# Safety Evaluation Report

Related to Renewal of the Facility Operating License  
for the University of Massachusetts Lowell Research  
Reactor

License No. R-125  
Docket No. 50-223

February 2022

**Figure 5-16 Loss of Flow Case 1 (Reactor Initially Operating at 1.25 MWt with Inlet Temperature 43.3 °C and Flow Rate 1,700 gpm)**

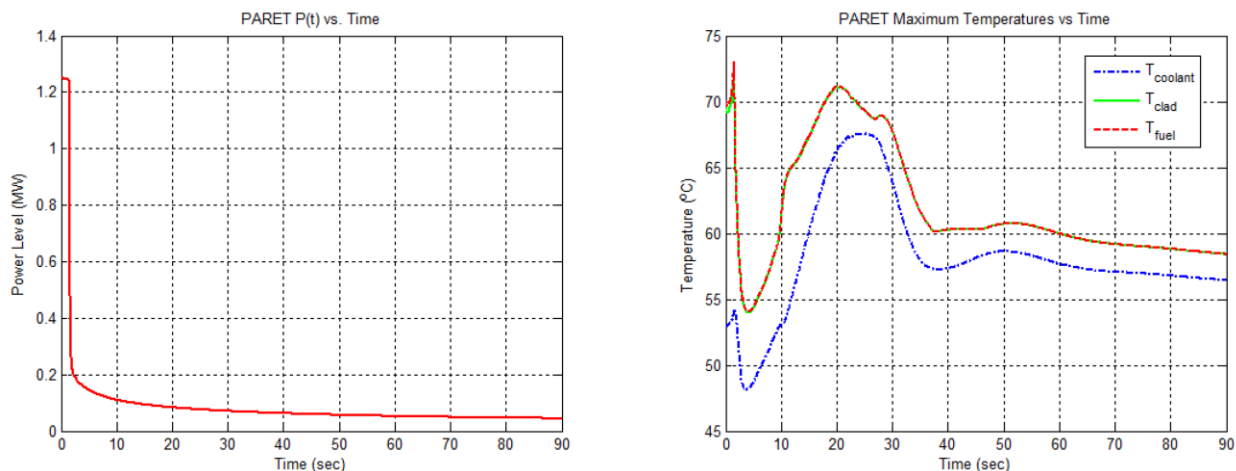
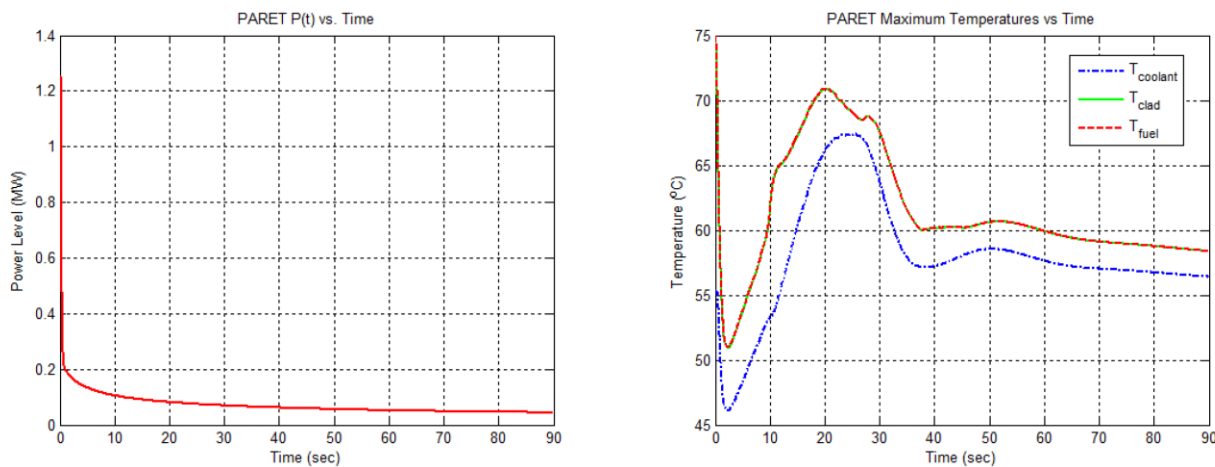
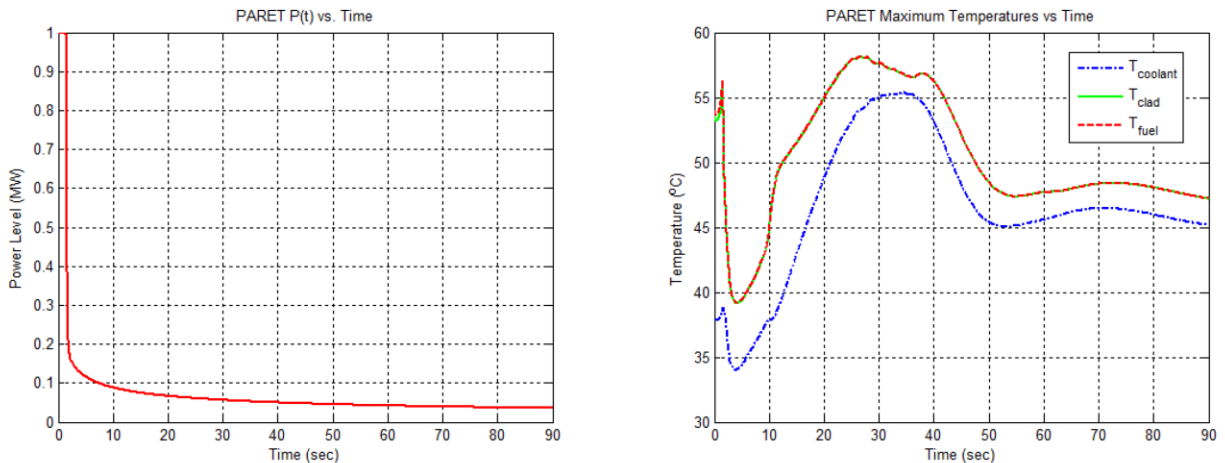
The figures show that the maximum fuel cladding temperature reached is about 75 °C (167 °F) for case 2 immediately prior to the scram, which is well below the SL, ONB, and temperatures at which any fuel failure could occur. UML noted that, for all three cases, the fuel temperatures quickly drop when the reactor scrams (for cases 1 and 3, there is a notable small increase in temperature before the reactor scrams from the decrease in flow rate prior to the scram). The temperature then rises back up as the pump flow rate continues to decrease, but falls again as natural convection flow is established.

The NRC staff calculated a maximum fuel cladding temperature of approximately 57 °C (135 °F), reached approximately 20 seconds after the pump shuts off. This is similar to UML's result for case 3, illustrated in SER Figure 5-18 above, which similarly assumed an initial reactor power of 1.0 MWt. Although the NRC staff's calculation did not consider a worst-case (i.e., LSSS) initial power level, the NRC staff finds that its calculation result illustrates the reasonableness of UML's results, and supports UML's determination that pump-off loss of flow scenarios would not cause the fuel to reach temperatures that could cause damage. The NRC staff also finds that the differences in its result and UML's results are reasonable given the differences in methodologies and assumptions used.

**Figure 6-1 UMLRR TS Figure 6-1**

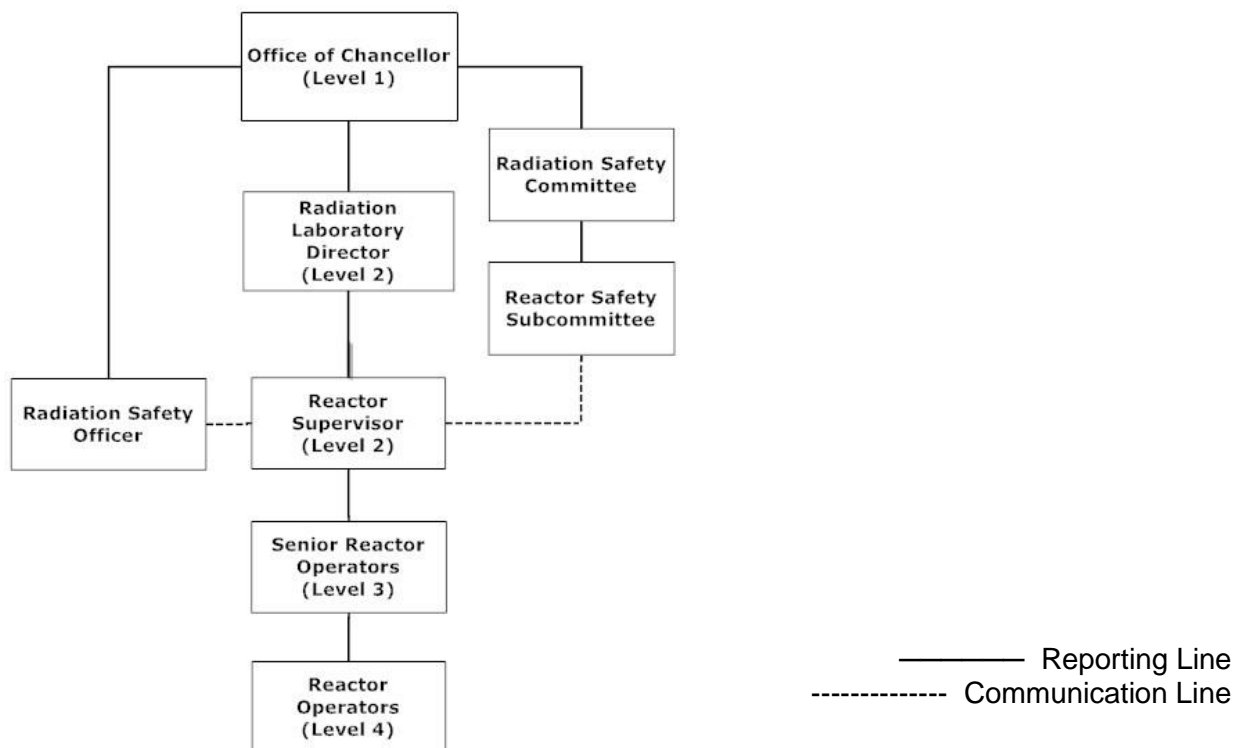
TS 6.1.1 would require that the structure of the UMLRR operating organization be as shown in TS Figure 6-1, which is reproduced below as SER Figure 6-1. As indicated by the TS Figure 6-1 caption, solid lines denote reporting lines, and dashed lines denote communication lines. The NRC staff finds that TS 6.1.1 helps ensure that the UMLRR organizational structure, including the communication and reporting lines, is appropriately defined and properly delineated in the TSs. The NRC staff finds that UML’s designation of two individuals as Level 2 authorities is appropriate, because both individuals have management authority over UMLRR operation, and because TS 6.1.1 (in conjunction with TS 6.1.2) clearly designates which Level 2 has the higher authority. The NRC staff also finds that by delineating the UMLRR organizational structure, TS 6.1.1 appropriately implements the guidance in NUREG-1537, Appendix 14.1, and ANSI/ANS-15.1-2007. Therefore, based on the above and based on its 10 CFR 50.36(c)(5) findings for TSs on administrative controls in SER Section 6.7, the NRC staff concludes that TS 6.1.1, including TS Figure 6-1, is acceptable.

TS 6.1.2 would require that the Level 1 authority indicated in TS Figure 6-1 be an individual at a position of associate vice chancellor or higher, who has overall responsibility for the UMLRR license, and is responsible for ensuring that UMLRR activities are in accordance with NRC regulations. TS 6.1.2 would also require that the Reactor Supervisor (lower Level 2 authority indicated in TS Figure 6-1) report to, and have direct responsibility to, the Director of the Radiation Laboratory (upper Level 2 authority indicated in TS Figure 6-1) for the safety of UMLRR activities and compliance with the UMLRR TSs; per TS Figure 6-1, the Director of the Radiation Laboratory in turn reports to the Level 1. TS 6.1.2 would additionally require that the UML campus radiation safety officer (RSO) (see SER Section 4.1.2) be responsible for radiation protection at the UMLRR, advise the Reactor Supervisor on all matters related to radiation protection, and report to and be directly responsible to the Level 1 in matters pertaining to radiation safety. The NRC staff finds that TS 6.1.2 helps ensure that the responsibilities of key positions in the UMLRR organizational structure, including responsibilities for compliance with the UMLRR license and NRC regulations, are clearly delineated. The NRC staff finds that TS 6.1.2, in conjunction with TS 6.1.1, helps ensure that the Level 1 authority is an upper-level UML official who has ultimate responsibility for the UMLRR license and who can make UML resources available as needed to ensure facility safety. Regarding TS 6.1.2, and other TSs in Section 6.0, "Administrative Controls," the NRC staff notes that it does not consider any personnel responsibilities, review requirements, procedure requirements, etc., delineated in the TSs to imply applicability for any purpose other than ensuring nuclear and radiological safety and that NRC requirements are met, with respect to activities conducted under NRC Facility Operating License No. R-125 for the UMLRR. The NRC staff also finds that by clearly defining the responsibilities to UML personnel as they relate to the UMLRR, TS 6.1.2 appropriately implements the guidance in NUREG-1537, Appendix 14.1, and ANSI/ANS-15.1-2007. Therefore, based on the above and based on its 10 CFR 50.36(c)(5) findings for TSs on administrative controls in SER Section 6.7, the NRC staff concludes that TS 6.1.2 is acceptable.
